## PRODUCT UPDATE- STANDARD LOCKERS

E-181211-1

# 72" SIDES

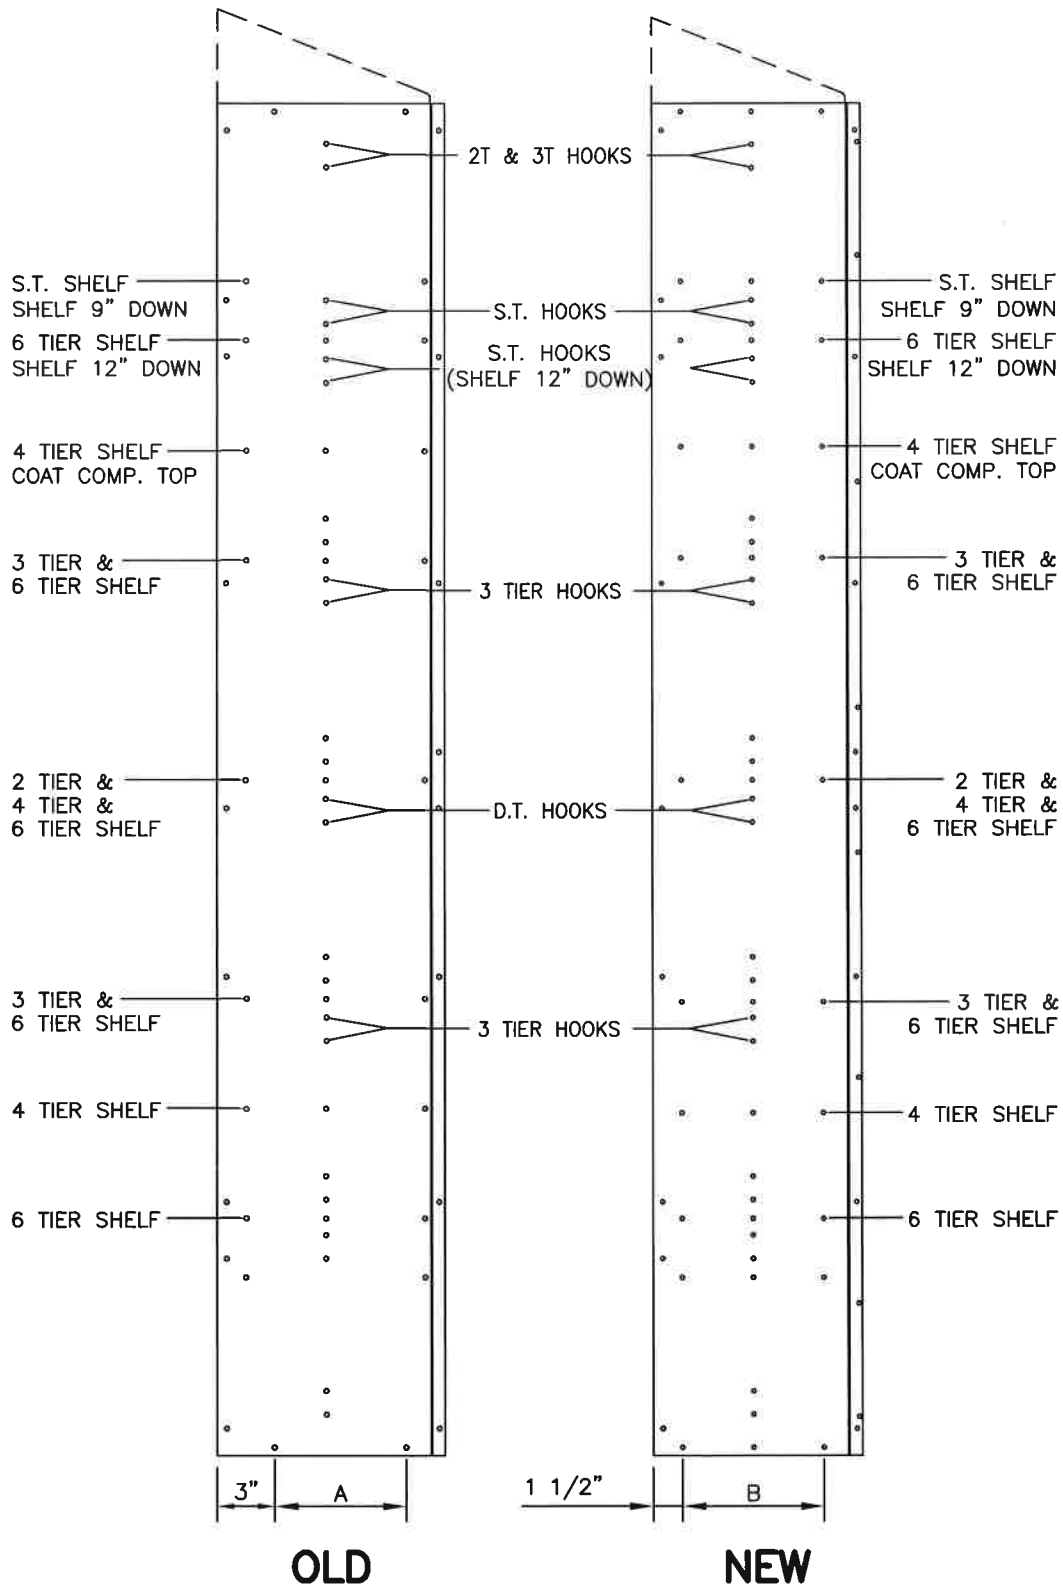
- 3 TIER AND 4 TIER PUNCHING WAS ADJUSTED VERTICALLY TO ACCOMMODATE ICM ON THE STANDARD SIDE
- TOP/BOTTOM AND SHELF PUNCHING HAS BEEN ALIGNED SO THERE IS A COMMON PUNCHING DIMENSION FOR TOPS, BOTTOMS, INTERMEDIATE BOTTOMS, AND SHELVES

# 60" SIDES

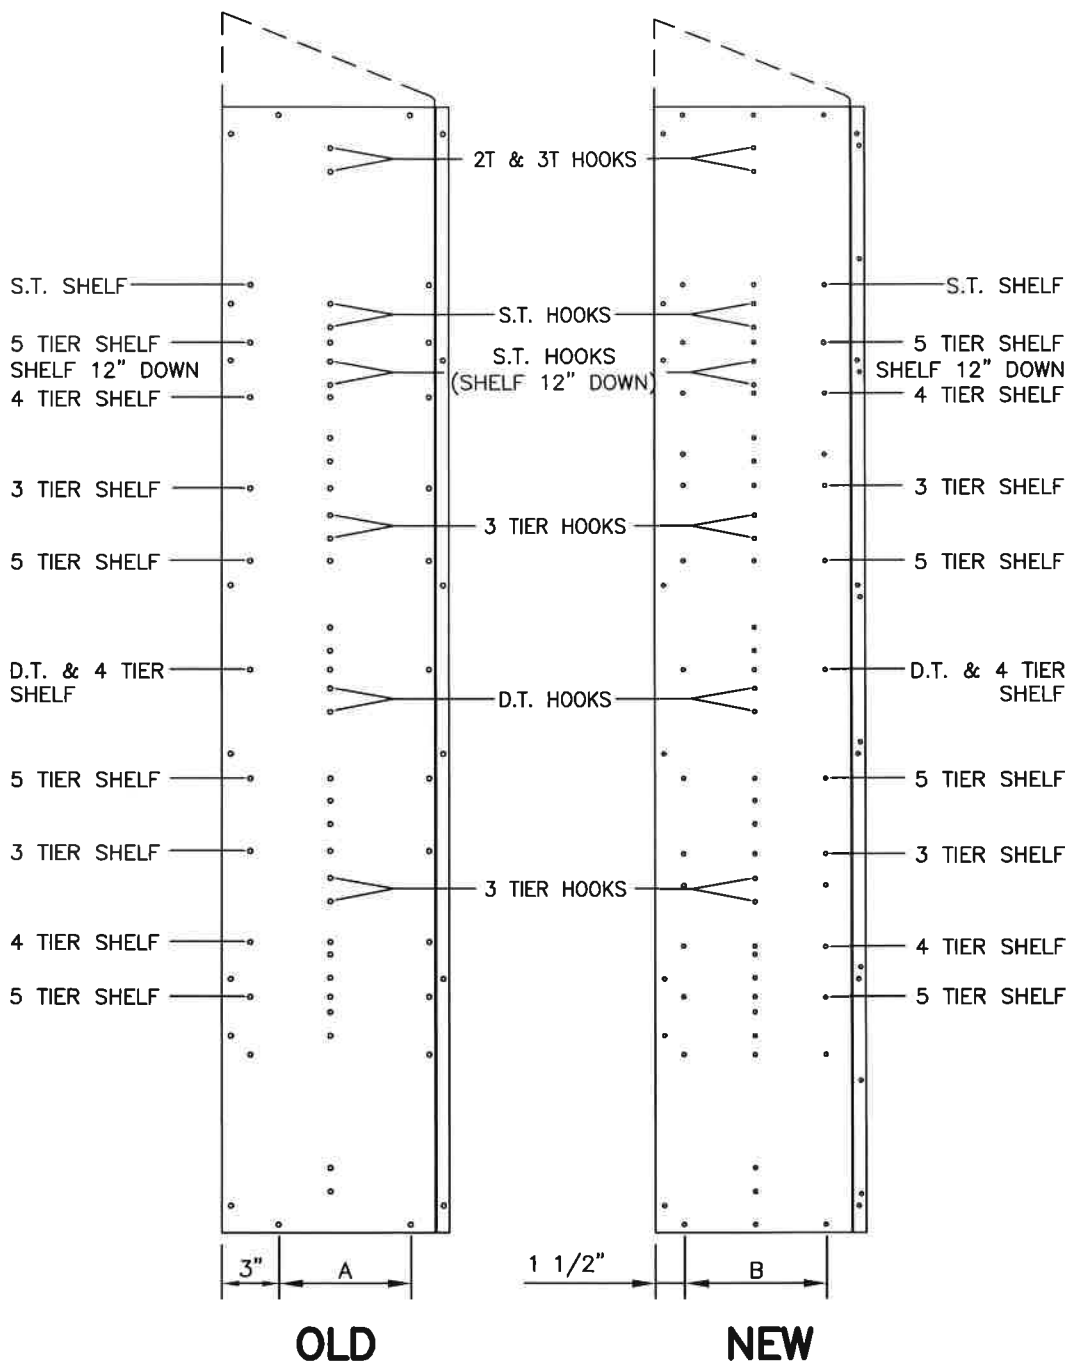
- 3 TIER AND 4 TIER PUNCHING WAS ADJUSTED VERTICALLY TO ACCOMMODATE ICM ON THE STANDARD SIDE
- TOP/BOTTOM AND SHELF PUNCHING HAS BEEN ALIGNED SO THERE IS A COMMON PUNCHING DIMENSION FOR TOPS, BOTTOMS, INTERMEDIATE BOTTOMS, AND SHELVES

# 72" BACKS

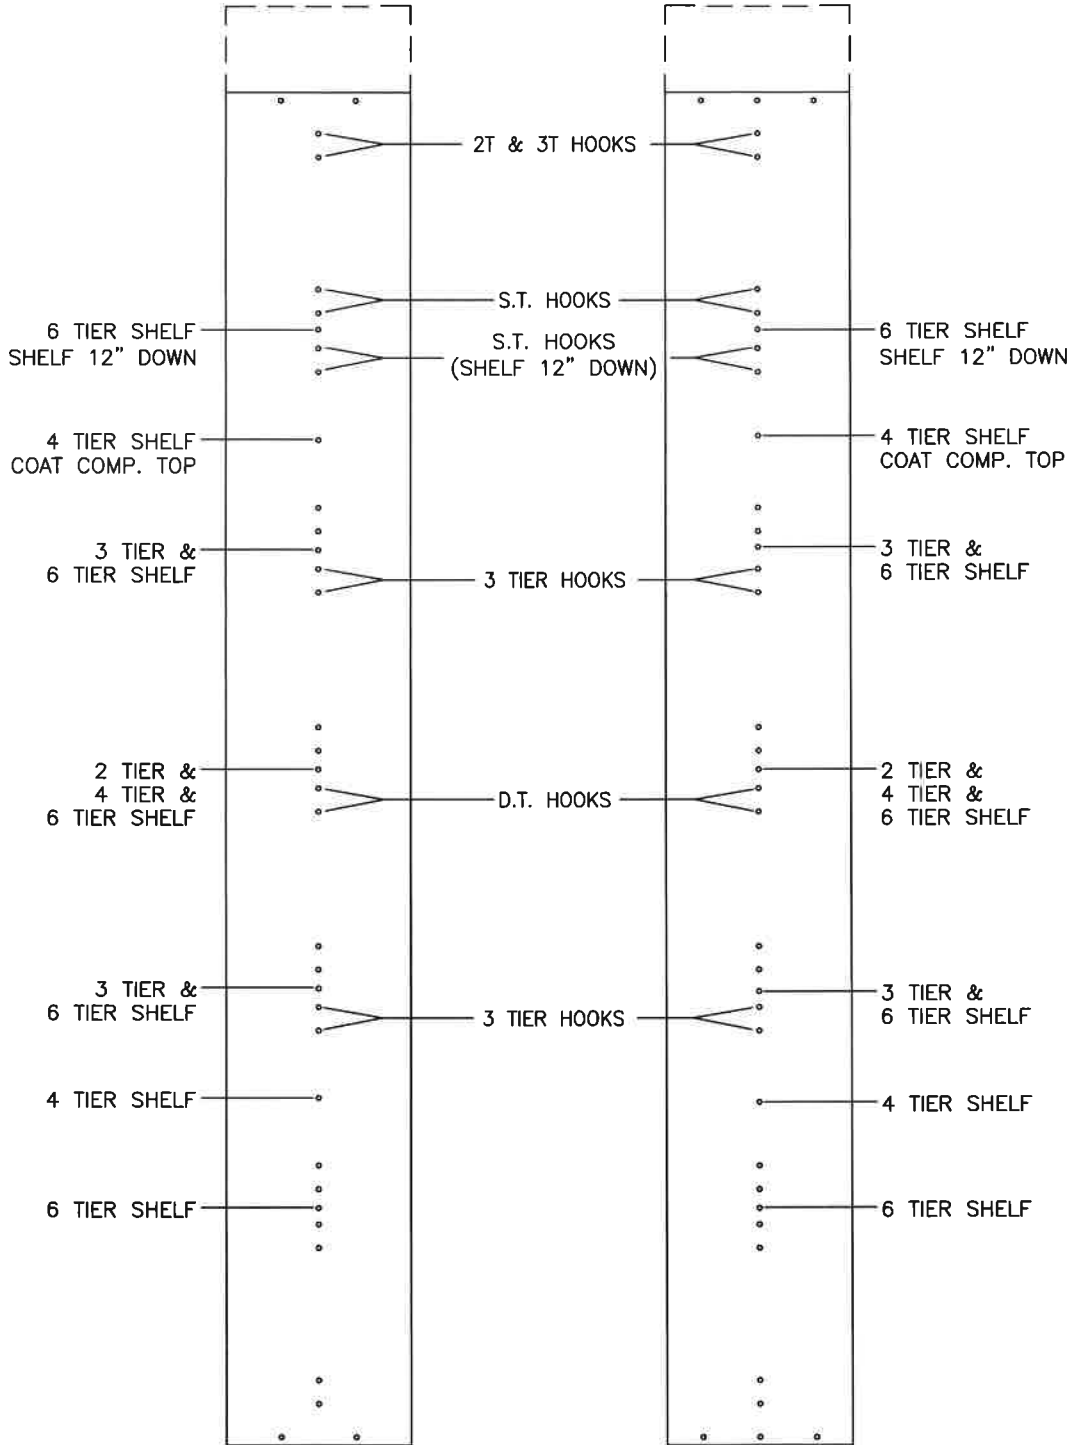
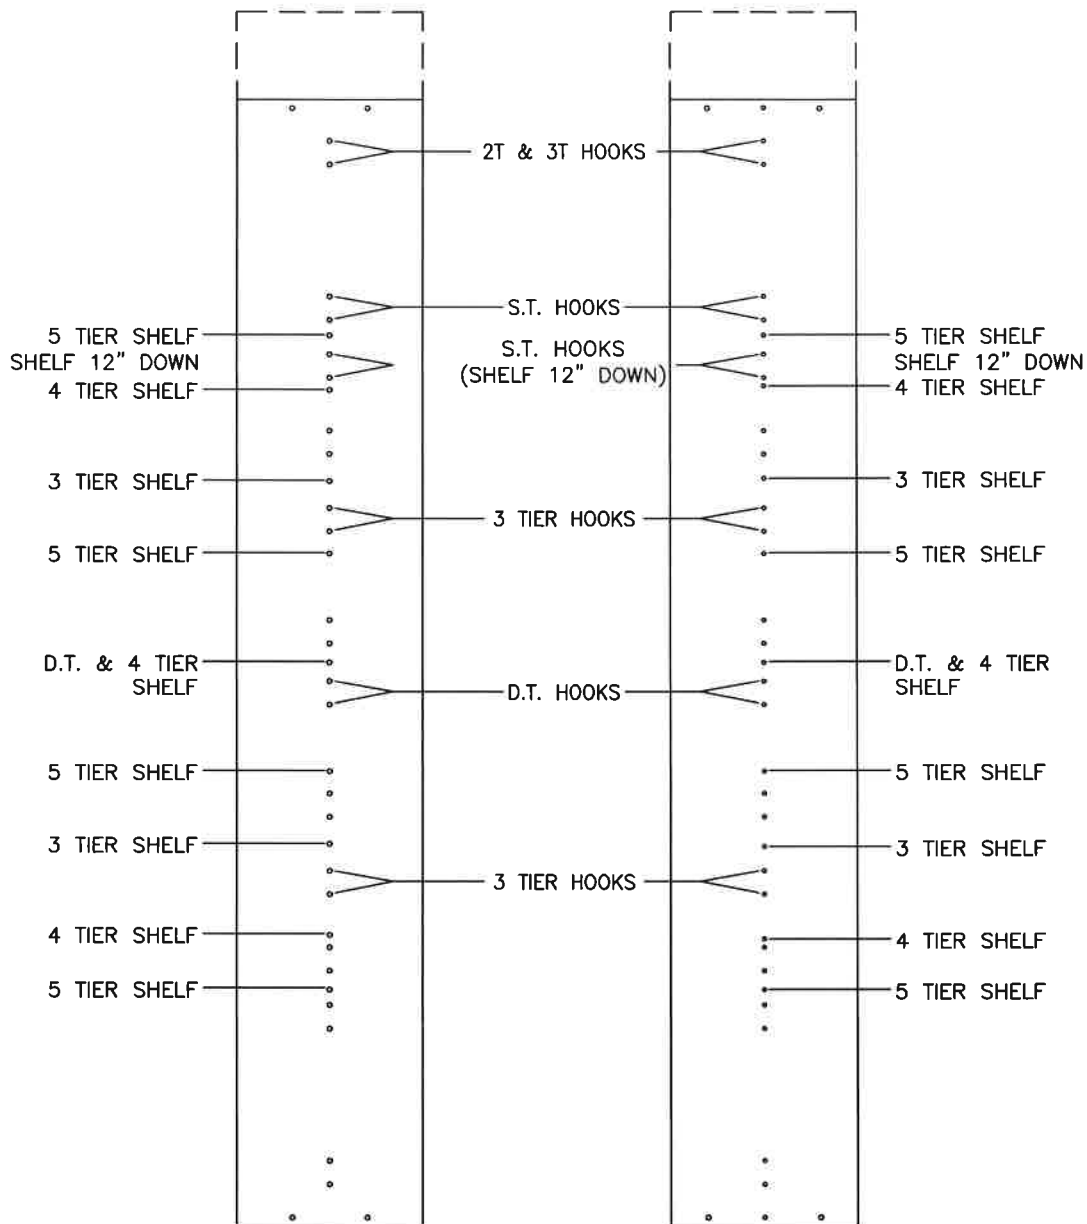
- 3 TIER AND 4 TIER PUNCHING WAS ADJUSTED VERTICALLY TO ACCOMMODATE ICM ON THE STANDARD SIDE
- CHECK DIMENSION ON SIDES TO DETERMINE WHICH STYLE OF BACK IS REQUIRED

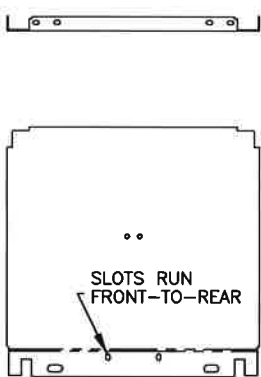
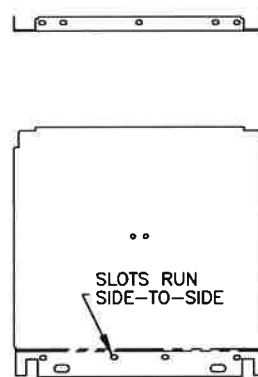
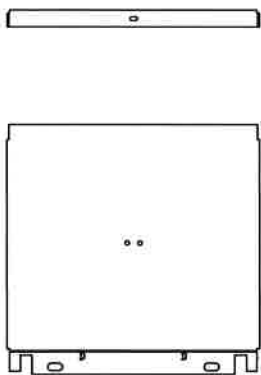
NOTE: NEW TOPS, BOTTOMS, AND SHELVES ARE COMPATIBLE WITH OLD STYLE LOCKERS. THERE IS NO NEED TO DETERMINE WHICH STYLE THE CUSTOMER HAS.
